**RE: ADDENDUM #4**

Project Address – 513 Garden Street

Prepared by: Mark Shkolnikov

The following is a list of responses to RFI's received up until the end of Friday, June 6<sup>th</sup>, 2014

# DESERT CRETE DECKING SYSTEM

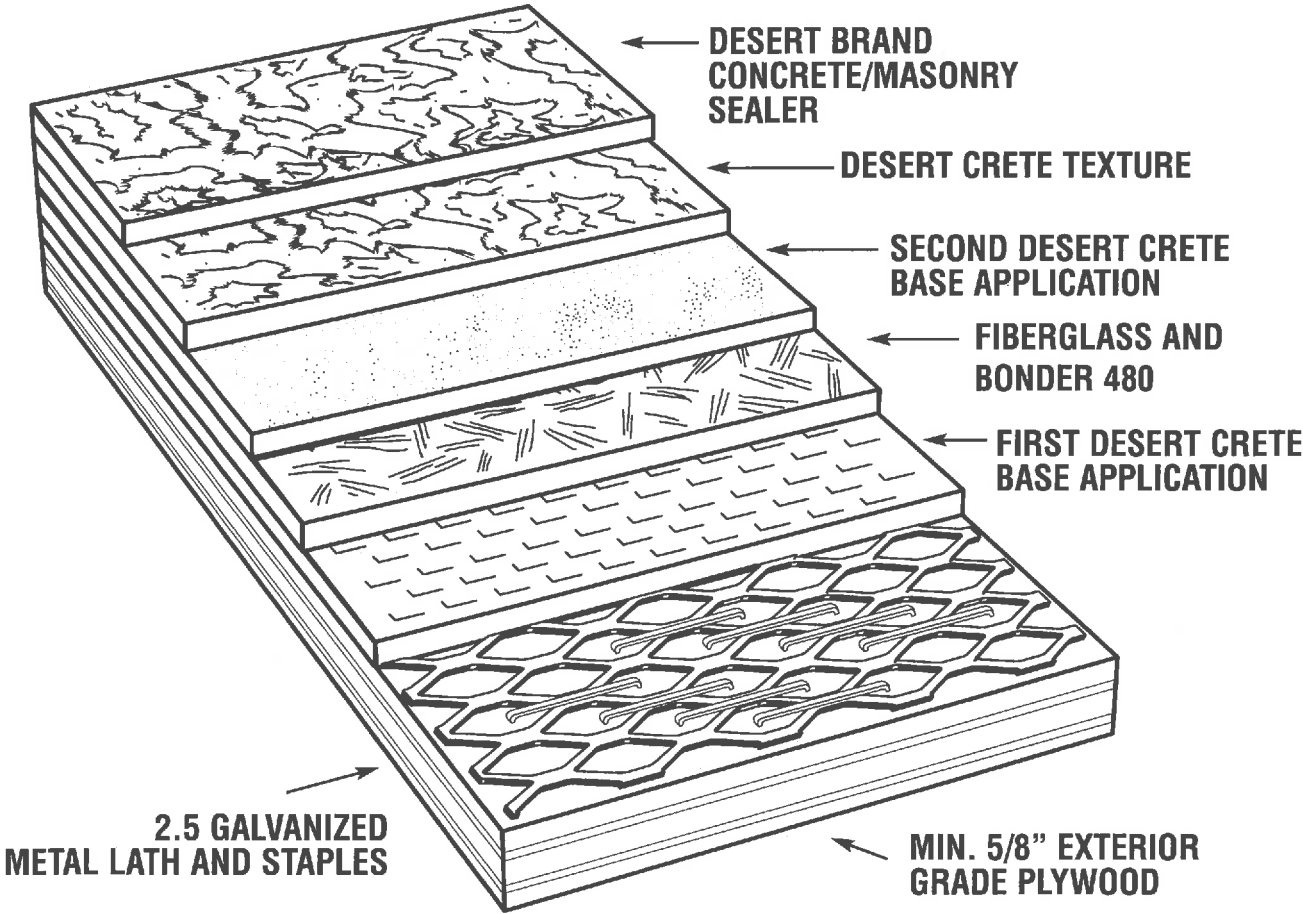
6. **The deck coating areas on the roof, shown in details on Sheet A8.4, indicate roof sheathing, furring, and another layer of sheathing. The structural plans identify the roof sheathing, but do not address the sheathing that is to be used for the deck coating substrate. What is the type and thickness of the deck coating substrate sheathing?**

**Response:** Per detail 1C/A8.4 – and in reference to the manufacturer’s ‘Tech Bulletin,’ we propose ¾” Exterior Grade Plywood.

**WATER TANK PAD FOOTING**

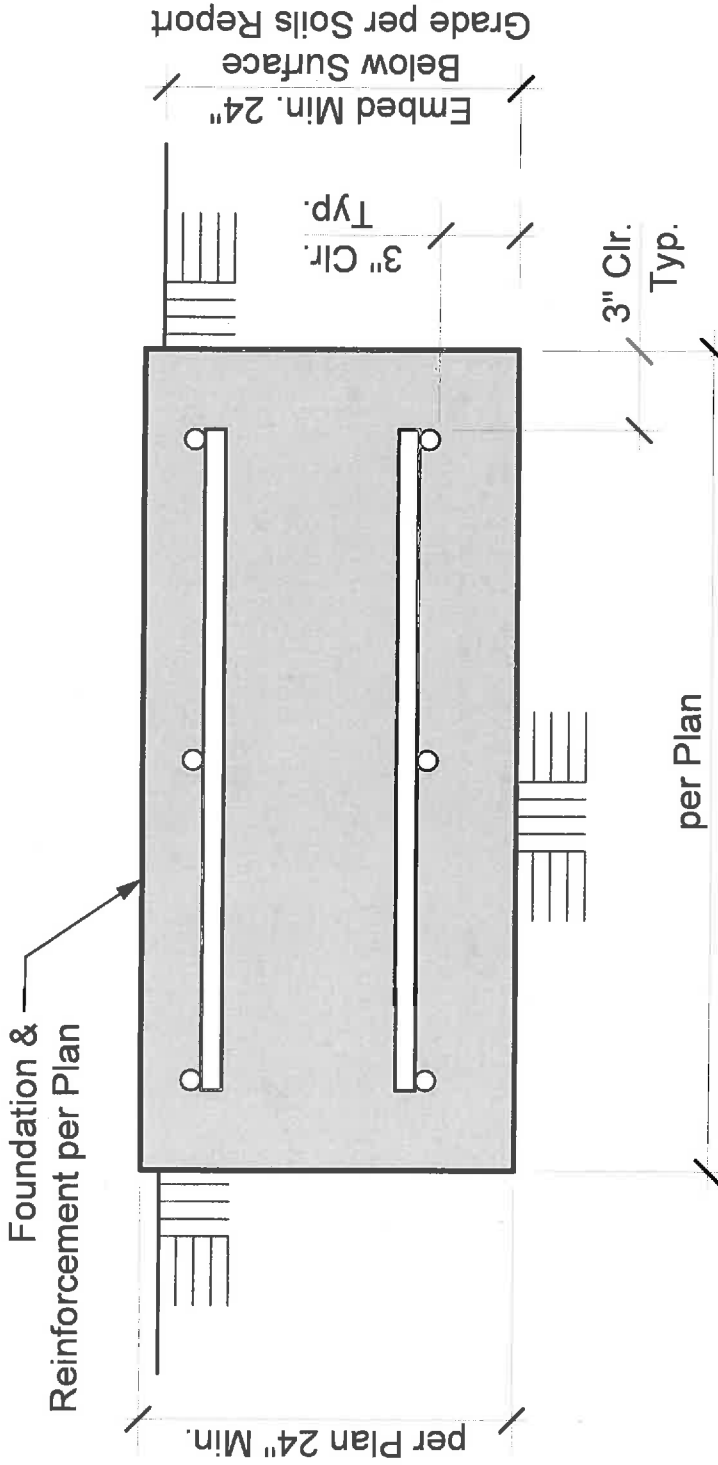
2. **Regarding detail 13/S3.4 6" clean free-draining material. This material is not defined and is substantial due to the amount of mat slab.**

**Responses:** The detail should have been labeled as pertaining to the water tank pad footings and updated as now provided. Please find attached the current detail 13/S-3.4. It is meant to provide further clarification for the two (2) water tank pad foundations near the existing workshop building.
